MEMORANDUM TO: Division 12 Environmental and Construction Units
FROM: *mat* Michael A. Turchy, ECAP Group Leader
Environmental Analysis Unit
SUBJECT: Environmental Permits for the I-40/I-77 Interchange in Iredell County,
Division 12, **TIP: I-3819B.**

T.I.P Project No. I-3819B
Proposed I-40/I-77 Interchange Area Improvements
Iredell County
WBS Element 34192.1.2

Action ID No. SAW-2018-01504

Subject: Modification to the 401 Water Quality Certification Pursuant to Section 401 of the Federal Clean Water Act with ADDITIONAL CONDITIONS for Proposed improvements to I-40/I-77 interchange improvements including I-40 from west of SR 2003 to SR 2158 and I-77 from south SR 2321 to south SR 2171 in Iredell County, TIP I-3819B, NCDWR Project No. 2019-1006v4.

PERMIT DRAWING
SHEET 30 OF 67
 Rev. 11/29/2022

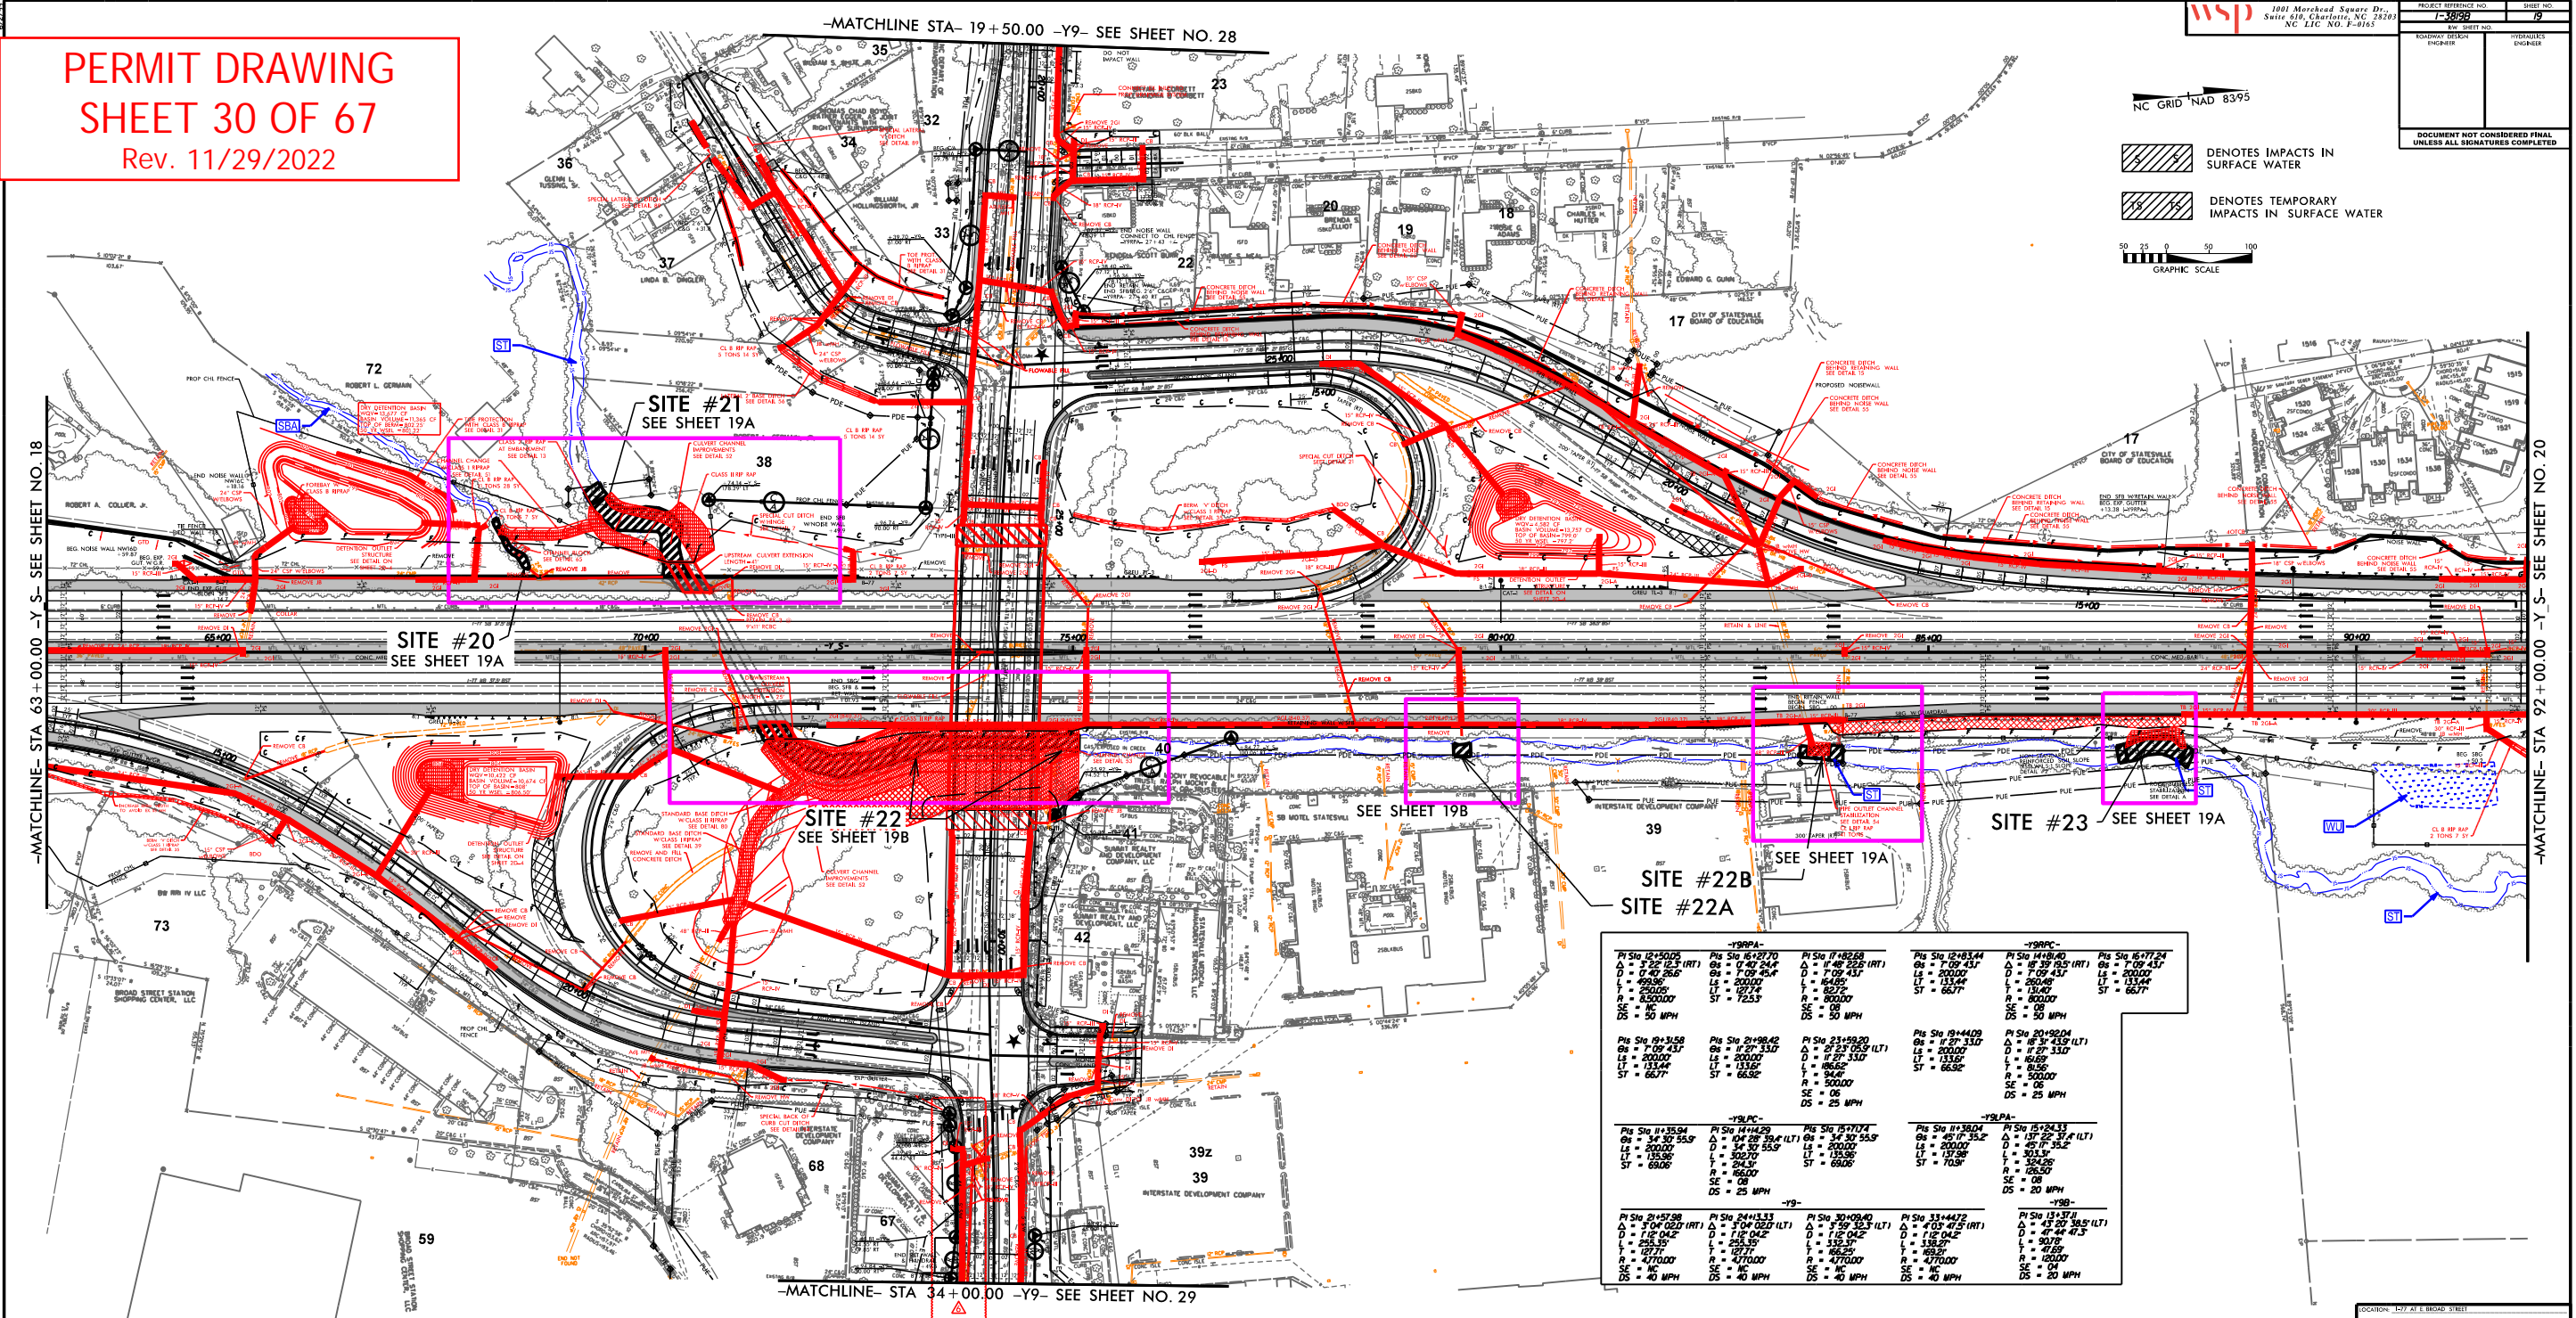
NOTE: AT THE DIRECTION OF NCDOT, JS LINES HAVE BEEN MODIFIED ALONG SITES 21, 22, AND 23 TO FOLLOW THE SURVEYED TOPOGRAPHY. NO RIPRAP WILL BE PLACED IN THE STREAM BED ALONG AREAS OF BANK STABILIZATION.

PERMIT DRAWING
SHEET 31 OF 67
 Rev. 11/29/2022

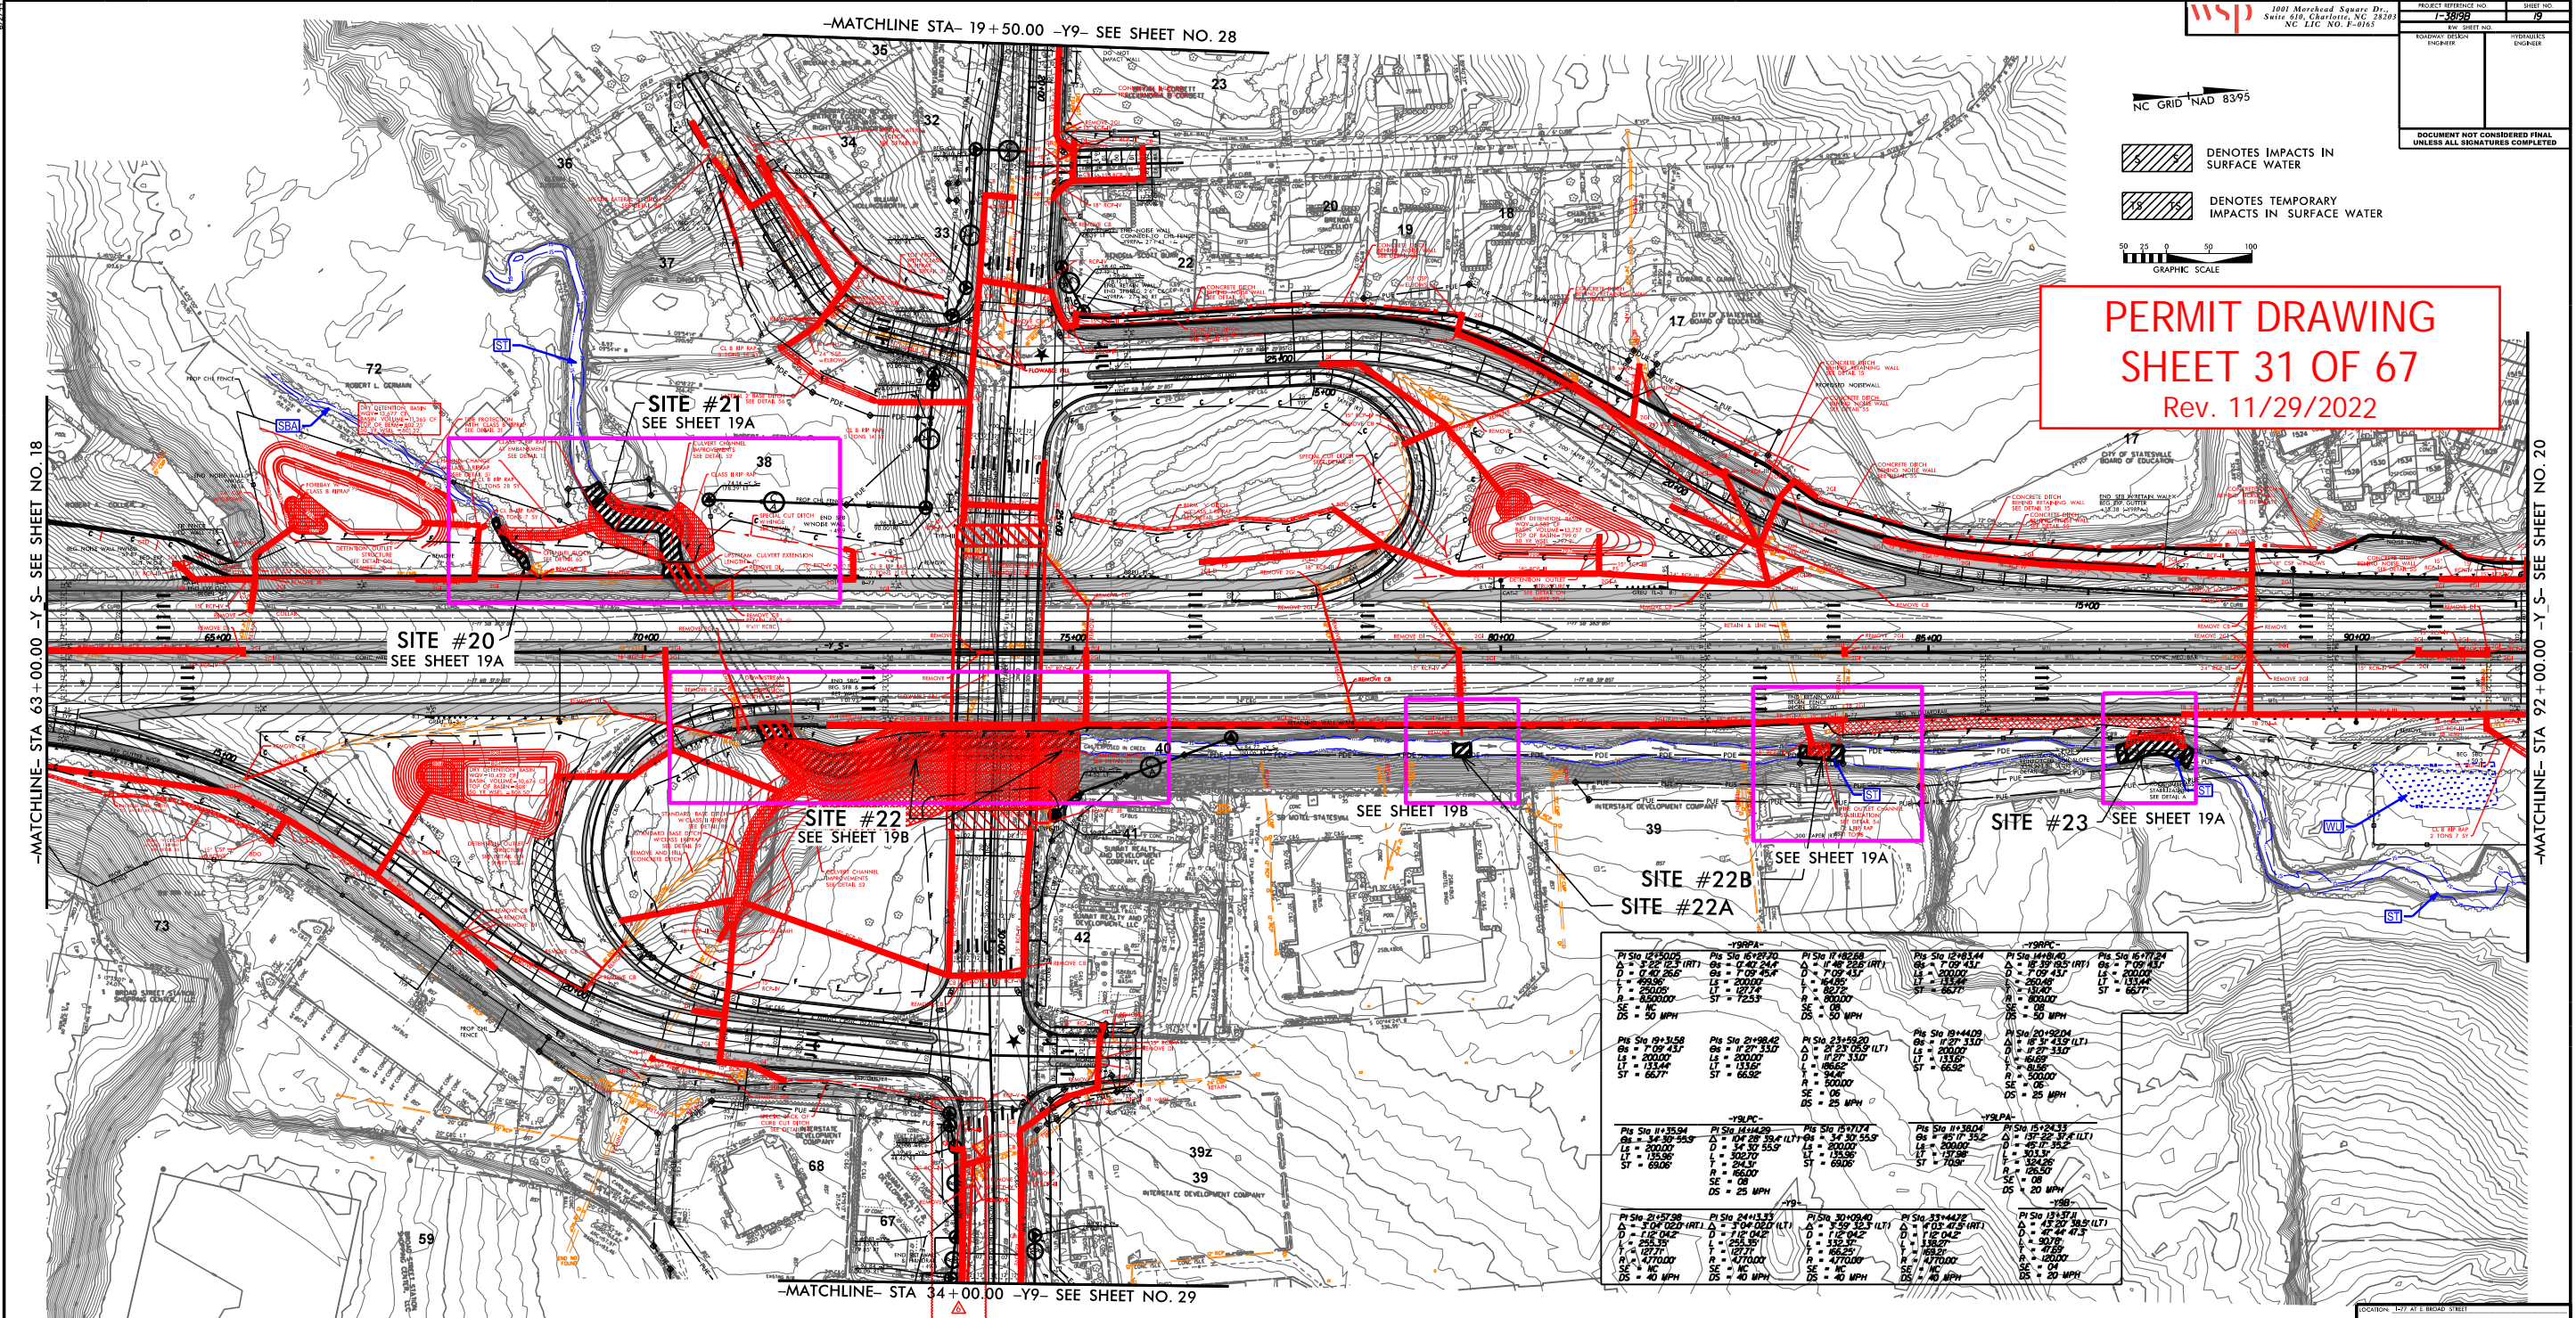
NOTE: AT THE DIRECTION OF NCDOT, JS LINES HAVE BEEN MODIFIED ALONG SITES 21, 22, AND 23 TO FOLLOW THE SURVEYED TOPOGRAPHY. NO RIPRAP WILL BE PLACED IN THE STREAM BED ALONG AREAS OF BANK STABILIZATION.

PERMIT DRAWING
SHEET 35 OF 67
 Rev. 11/29/2022

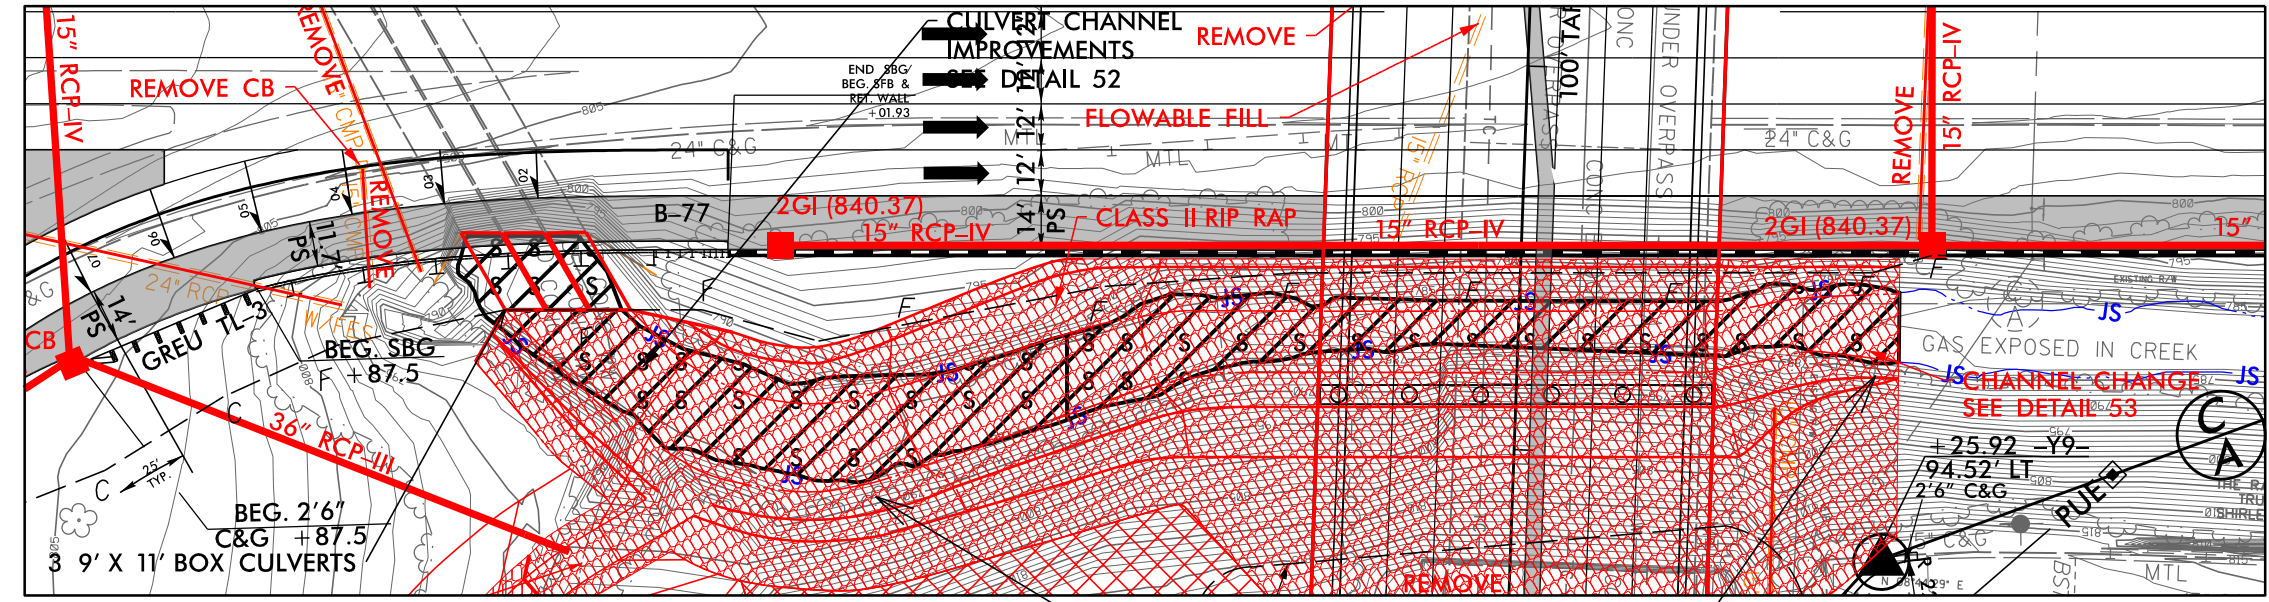
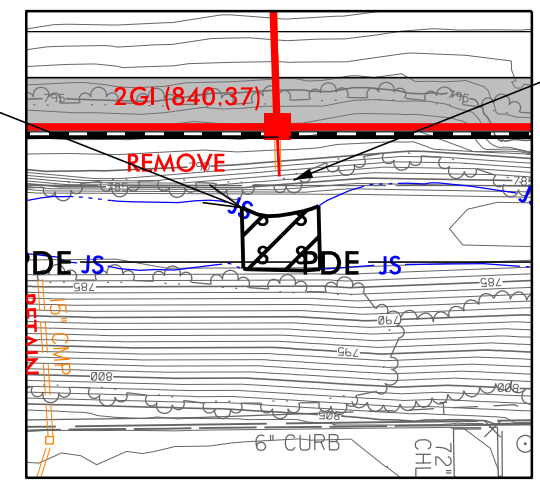
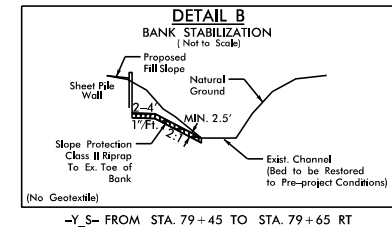
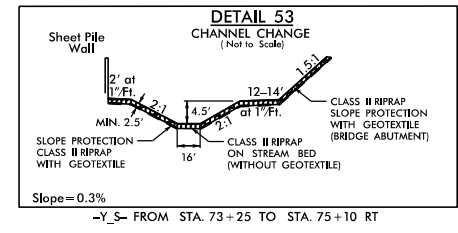
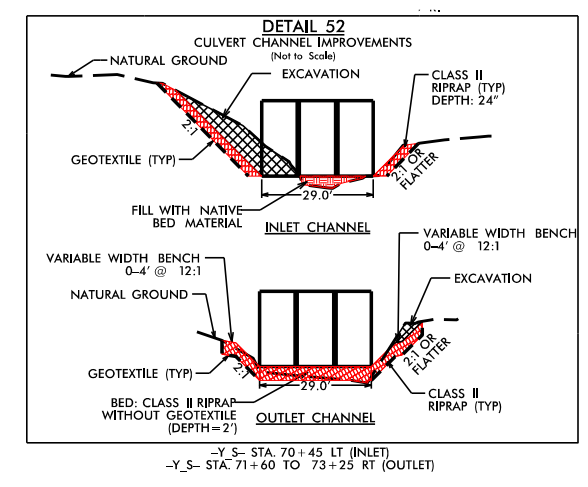
NOTE: AT THE DIRECTION OF NCDOT, JS LINES HAVE BEEN MODIFIED ALONG SITES 21, 22, AND 23 TO FOLLOW THE SURVEYED TOPOGRAPHY. NO RIPRAP WILL BE PLACED IN THE STREAM BED ALONG AREAS OF BANK STABILIZATION.

BANK STABILIZATION MAY BE NEEDED AFTER EXISTING PIPE IS REMOVED. USE DETAIL B AS NEEDED*.
